North Dakota CarbonSAFE: Project Tundra Oliver County, North Dakota

**APPENDIX J – AIR PERMIT TO CONSTRUCT, AIR QUALITY EMISSIONS
ANALYSIS, AND AIR QUALITY IMPACT ANALYSIS**

Re: Application of DCC East Project LLC for Permit to Construct No. ACP-18194 for
Dakota Carbon Center CO₂ Separation and Purification Plant

Response to Comments Received
by
The North Dakota Department of Environmental Quality
on
Draft Air Pollution Permit to Construct No. ACP-18197 v1.0
DCC East Project LLC - Dakota Carbon Center CO2 Separation and Purification Plant
Oliver County, North Dakota

Figure A-1. Site Layout

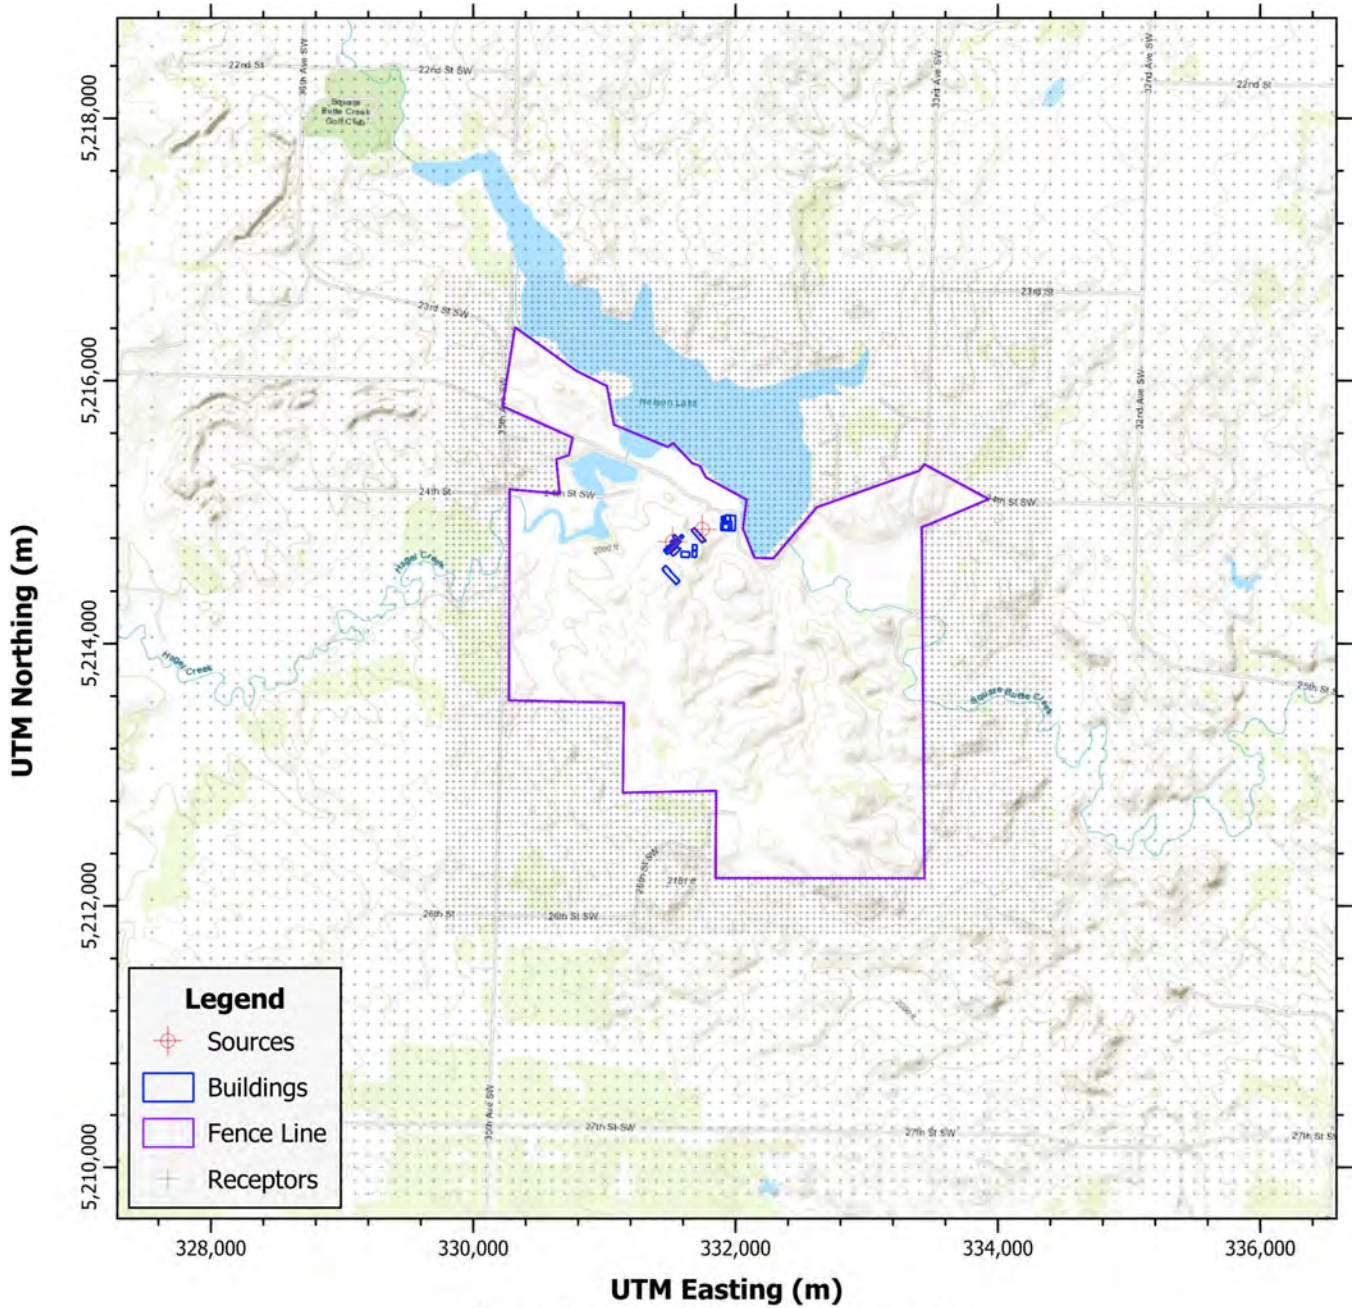
Figure A-1 in Appendix 2 of the AQIA establishes what appears to be an ambient air boundary for the facility that is used to delineate where the air dispersion modeling receptor grid is located. This receptor grid is shown in Figure A-4 and excludes the area inside the defined ambient air boundary.

However, in the permit’s June 2, 2023 application, in Figure 2-1, the larger ambient air boundary contains a smaller defined area labeled as the DCC Separation and Purification Plant and locates the MRY facility’s Unit 1 and Unit 2 in relationship to the DCC facility. The larger ambient air boundary area used in the air dispersion modeling process to establish the modeling receptor grid appears to be the MRY ambient air boundary and the DCC ambient air boundary, according to Figure 2-1 appears to be a smaller area located within the MRY boundary. As it contains MRY Unit 1 and Unit 2, this would appear to be the MRY ambient air boundary.

DCC Response: In its comments, EPA Region 8 recommended that NDDEQ review the cited documents and confirm that the ambient air boundary and associated receptor grid used in the air dispersion modeling for the DCC Facility for accuracy. If that boundary is different than the one used to define the model’s receptor grid, then EPA recommended that the NDDEQ or the applicant rerun the model to confirm that no NAAQS concerns exist.

Minnkota maintains a fenced physical barrier preventing unauthorized entry of the public into the MRY Station. DCC East used the fenced MRY Station property boundary in its modeling demonstrations. The fenced barrier will remain after the start-up of the DCC Facility. The proposed operation plan for the DCC Facility consists of use of the existing MRY Station security gate for designated access across Minnkota property to the DCC Facility secured site. The DCC Facility will be located on leased property, adjacent to the MRY Station, and will be considered “nested” within the footprint of Minnkota’s access restrictions. The MRY Station is a critical infrastructure site and requires strict adherence to security protocols to mitigate access risk. As

NDDEQ has confirmed the accuracy of the ambient air boundary and associated receptor grid used for the air dispersion modeling. To address this comment, DCC has better outlined the site access and security requirements, the lessor/lessee relationship, and reference to contractual agreements which transfers the “pass through⁵” flue gas back to MRY. This information is provided in detail in Appendix A.5.i, pages 5 and 6.
